Access Compliance Report

Public Rights-of-Way

Intersection ID: 30176	Main Street: FAIRSTONE_AV	Cross Street: MENTONE_LN	Location:	N
ADA ID: C0FB98145E29	Ramp Type: BlendTrans1	Initial Pass/Fail: Fail	Overall Compliance: No	Severity Score: 8.75

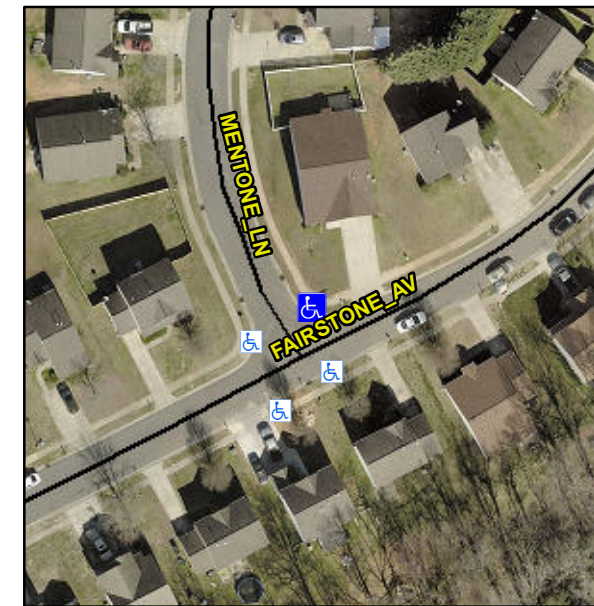
Not Found, R304.5.1

Compliance	Description	Data	Compliance	Description	Data
N/A	Ramp Length (in)	49.5	Yes	BlendTrans Slope (%)	3.8
No	Ramp Width (in)	47.0	Yes	BlendTrans XSlope (%)	0.6
N/A	Flare Type LT	N/A	N/A	Flare Type RT	N/A
N/A	Flare Slope LT (%)	N/A	N/A	Flare Slope RT (%)	N/A
N/A	Flare Traversable LT?	N/A	N/A	Flare Traversable RT?	N/A
N/A	Landing Length (in)	N/A	N/A	DWS Provided?	N/A
N/A	Landing Width (in)	N/A	N/A	DWS Contrast?	N/A
N/A	Landing Slope (%)	N/A	N/A	DWS Length (in)	N/A
N/A	Landing X Slope (%)	N/A	N/A	DWS Full Width?	N/A
N/A	Landing Curb? (Y/N)	N/A	N/A	DWS Offset (in)	N/A
N/A	Shared Landing?	N/A			
N/A	Gutter Ponding?	N/A	N/A	Gutter Slope (%)	N/A
N/A	Gutter Lip Ht (in)	1.5	N/A	Gutter X Slope (%)	N/A
N/A	Painted X Walk1?	No	N/A	Painted X Walk2?	No
	X Walk 1 Direction	To SW		X Walk 2 Direction	To SE
	X Walk 1 Width (in)	N/A		X Walk 2 Width (in)	N/A
	X Walk 1 Slope (%)	4.3		X Walk 2 Slope (%)	0.9
	X Walk 1 X Slope (%)	1.9		X Walk 2 X Slope (%)	1.5

N/A	Ramp inside XWalk1?	N/A	N/A	Ramp inside XWalk2?	N/A
	Road Slope (%)	0.5		Clear Space?	N/A
	Road X Slope (%)	1.7	N/A	Clear Space to XWalk (in)	N/A
N/A	Any Obstructions?	N/A	N/A	Storm Grate/Utility Hazard?	N/A
	Obstruction Type			Storm Grate/Utility Type	
		N/A			N/A
			Yes	Surface Condition? (G/P)	Good
			No	Curb Slope (%)	13.5

Remove & Replace Curb Ramp With Two New Directional Ramps or Equivalent.
